Midway City Council
20 September 2022
Regular Meeting

The Village /
Underground Garages

CITY COUNCIL MEETING STAFF REPORT

Subject: **Hydrogeologic Assessment - Proposed "The Village" Subdivision**
Midway City, Wasatch County, Utah
for Horrocks Engineers, Inc.

Figure 2

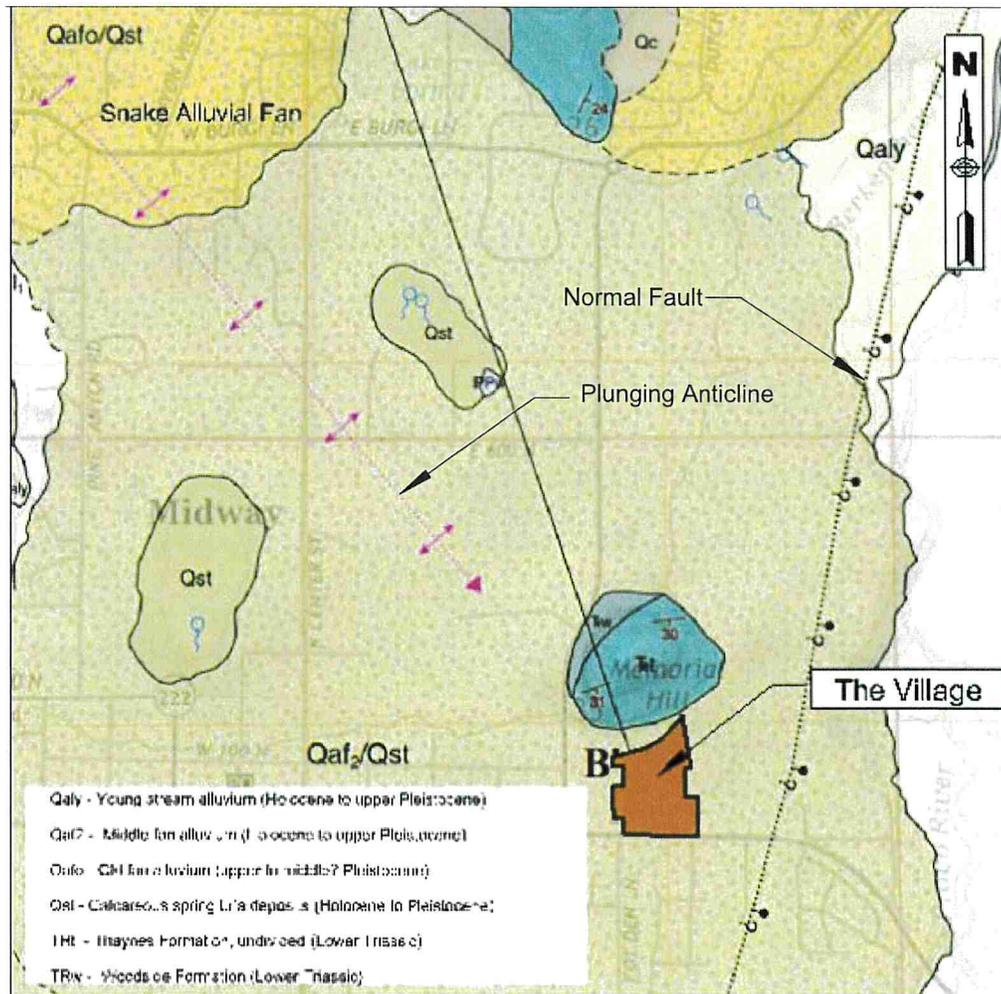
CMT (2017a, 2017b, and 2021a) performed multiple geotechnical investigations during 2017 and 2021. Figure 2 shows the locations of borings and test pits completed by CMT from 2017 to 2021. Except for borings B-1A, B-2A, and B-3A, CMT test pits and borings intercepted thin soils overlying tufa deposits.

- Conducted a third geotechnical investigation during 2021 (CMT, 2021a), this time for The Village, in which they:
 - Excavated and logged 10 test pits to a depth of about 10 feet below ground surface, two of which were excavated adjacent to Borings B-2 and B-4 and were dry (see Figure 2 for locations);

About 0.94 feet of water was measured the slotted pipe in Test Pit TP-3 on June 24, 2022; however, Table 2 shows TP-3 as “Dry” because the pipe was in a water-filled depression and the measurement is believed to be suspect. The water levels measured in Borings B-2 and B-4 (estimated elevations between 5,559 to 5,574 feet) lie above the elevations of the regional aquifer (estimated at about 5,550 feet). These elevations are also higher than the proposed design of the storm and sewer drains (Berg, 2022).

Figure 6

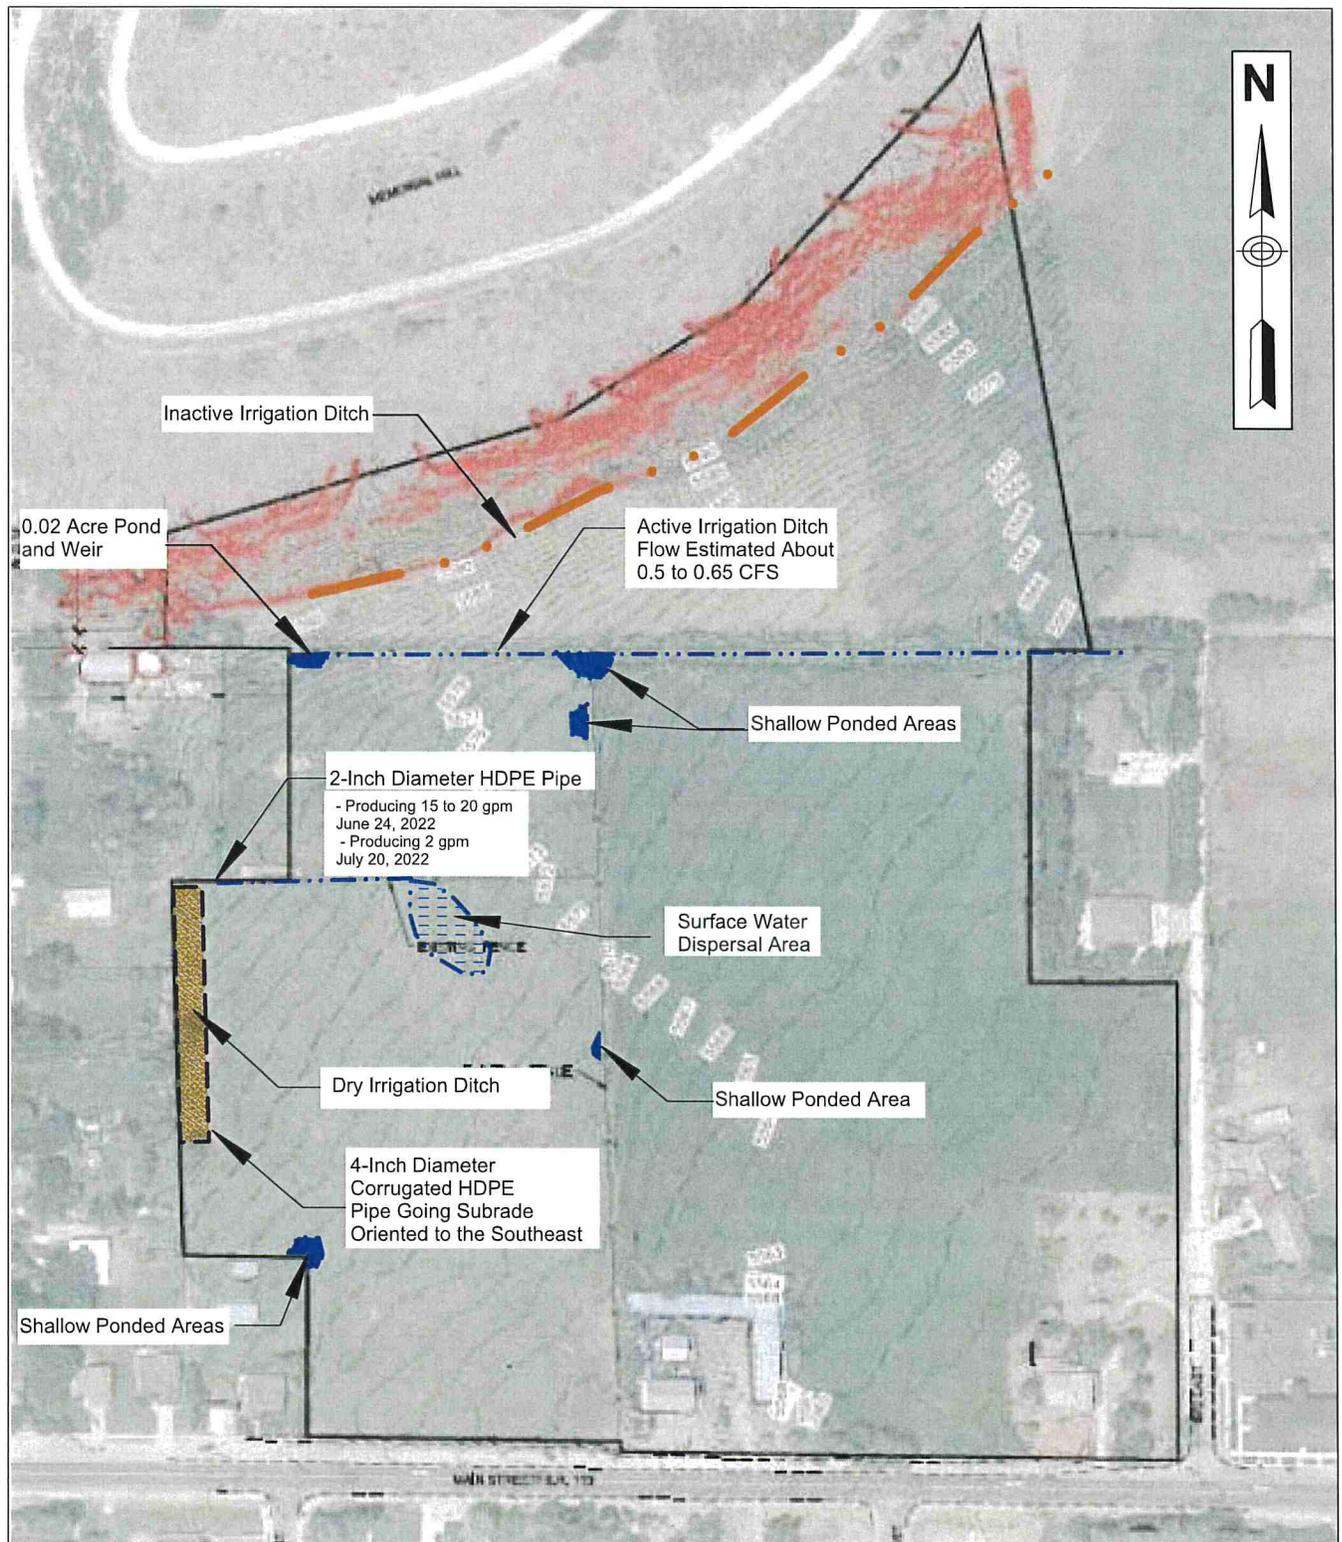
- Low spots, shown on Figure 6 containing ponded surface water, we assume, from forced site irrigation of overlying low-permeability soil;
- A dry irrigation ditch on the east side of the property draining to a subgrade 4-inch diameter corrugated high-density polyethylene (HDPE) pipe;
- A 2-inch diameter HDPE pipe discharging into an east-west shallow channel that dispersed water to the southeast (at the approximate location shown on Figure 6) via flood irrigation; and
- An unlined irrigation ditch conveying water from west to east through the northern part of the property

Nearly all these surface water features are at elevations that are higher than the water levels observed in slotted pipe in borings B-2 and B-4 on October 27, 2017. We measured a small amount of water in TP-3, but also observed surface water ponded around the pipe. Ponded locations on the surface soils confirm the NRCS assessment that the surface soil has a low vertical infiltration rate; see Attachment 3.
